# Work Order ID 111800

Item Name: Crosstube Turning Detail

<b>DART AEROSPACE LTD</b>		<b>Work Order:</b>	111800
<b>Description:</b> Crosstube Assembly (205/212/412 High Fwd)		<b>Part Number:</b>	D212-664-141
<b>Inspection Dwg:</b> D212-664-141 <b>Rev:</b> D		<b>Page 1 of 2</b>

DRAWING NO. D212-664-141	TITLE XTUBE ASSY (205/212/412 HI FWD)	REV. D	DART AEROSPACE LTD ENGINEERING ORDER		D.E.O. NO. D212-664-141-D-1	SHEET NO. SHEET 1 OF 2	SCALE NTS
DRAWN	CHECKED	MP	MFG. APPR.	APPROVED	MP	DE APPR.	
DATE 11.04.07	DATE 11.04.11		DATE 11.04.12	DATE 11/04/12		DATE 11.04.12

**D212-664-141/-141B  
ASSEMBLY DETAIL**

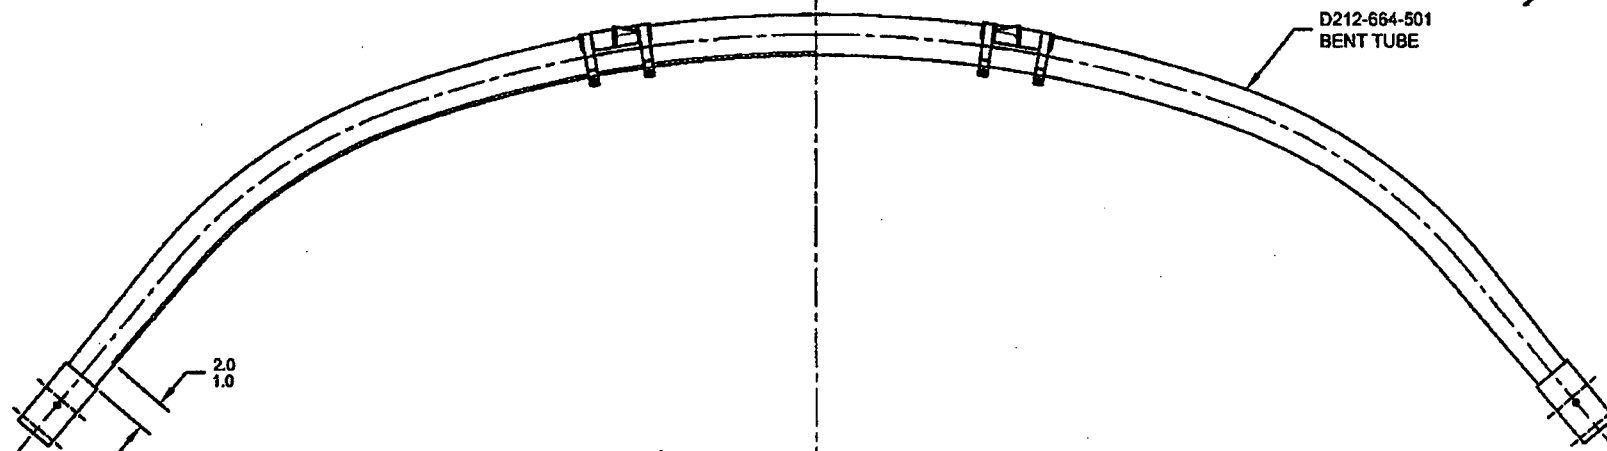
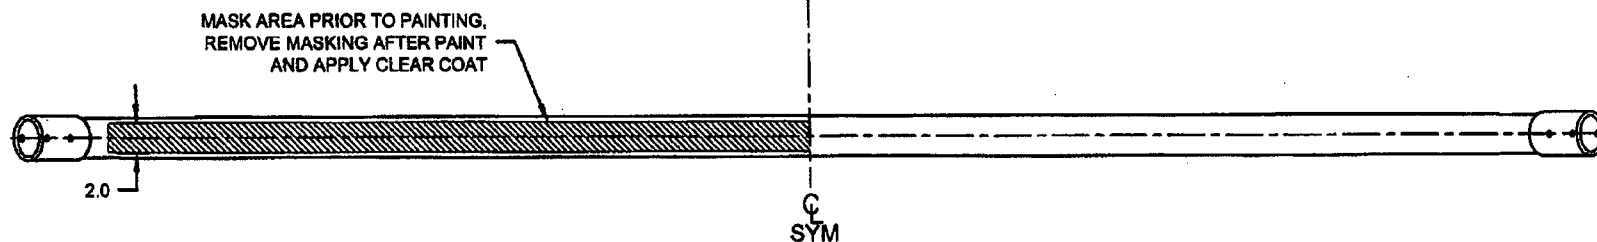
ADD AN INSPECTION WINDOW TO UNDERSIDE OF CROSSTUBE.

NOTES 2 OF SHEET 1 IS AMENDED AS FOLLOWS:

- 2) FINISH: CHEMICAL CONVERSION COAT PER DART QSI 005 4.1  
PRIME INSIDE AND OUTSIDE PER DART QSI 005 4.2  
MASK UNDERSIDE OF CROSSTUBE AS SHOWN (HATCHED AREA) AND  
PAINT OUTSIDE PER DART QSI 005 4.2  
REMOVE MASKING AND APPLY CLEAR COAT

- 2) FINISH: CHEMICAL CONVERSION COAT PER DART QSI 005 4.1  
PRIME INSIDE AND OUTSIDE PER DART QSI 005 4.2  
PAINT OUTSIDE PER DART QSI 005 4.2
